MANDATORY SERVICE BULLETIN NO. MSB40-02 Revision 1 (supersedes Revision -)

DA 40 serial numbers 40.005 through 40.022

Due to manufacturing problems the quality of the tubing ends of the steel tubes in the wheel brake system is inadequate. To improve the design the steel tubes have been replaced by Teflon hoses. This MSB describes this replacement.

fig. 1

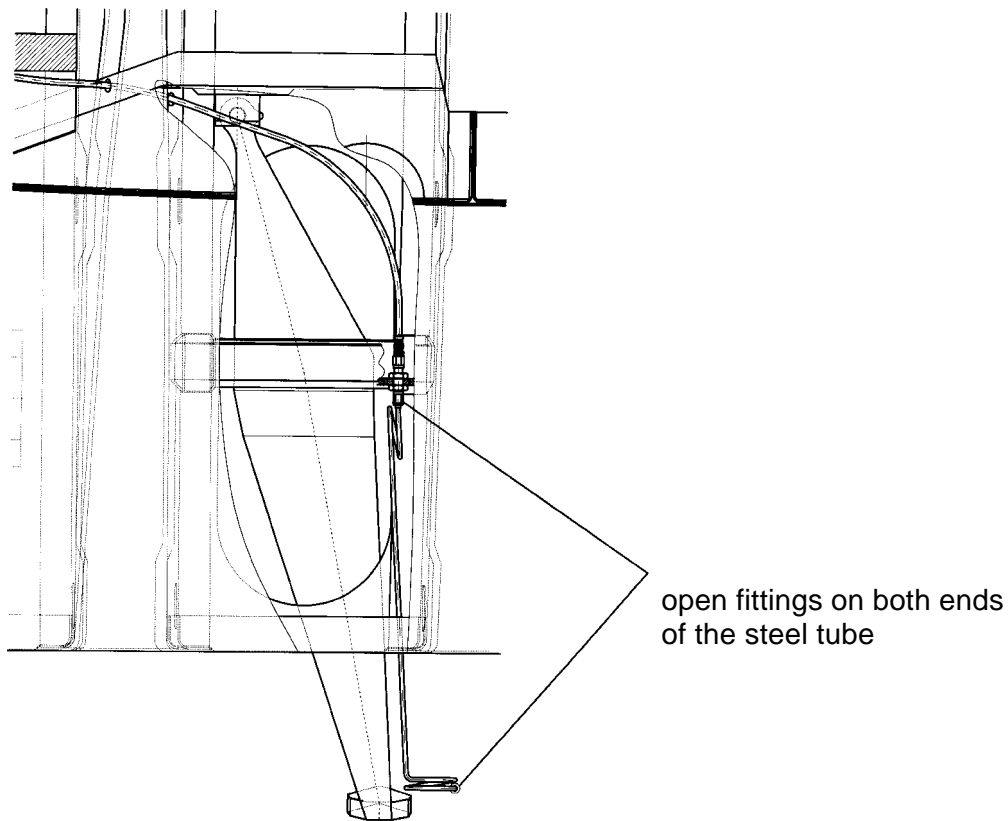
1. empty the brake system according to the AMM
2. remove the steel tube by open the fittings on both ends (see fig. 1)

3. remove the 45° elbow at the brake caliper
4. install the 90° elbow at the brake caliper

fig. 2

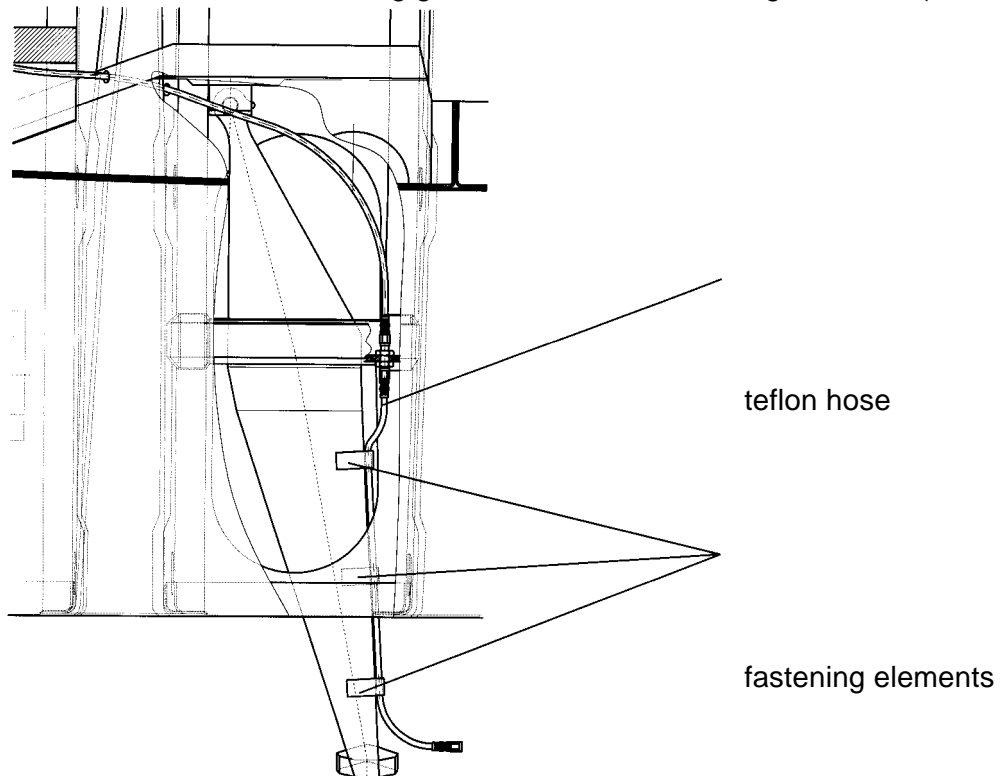
5. glue the fastening elements to the main landing gear strut with MS 9380 adhesive (see fig. 2)
6. attach the Teflon hose at both ends to the fittings, close the fittings and fix the Teflon hose to the main landing gear strut with the fastening elements (see fig. 2)
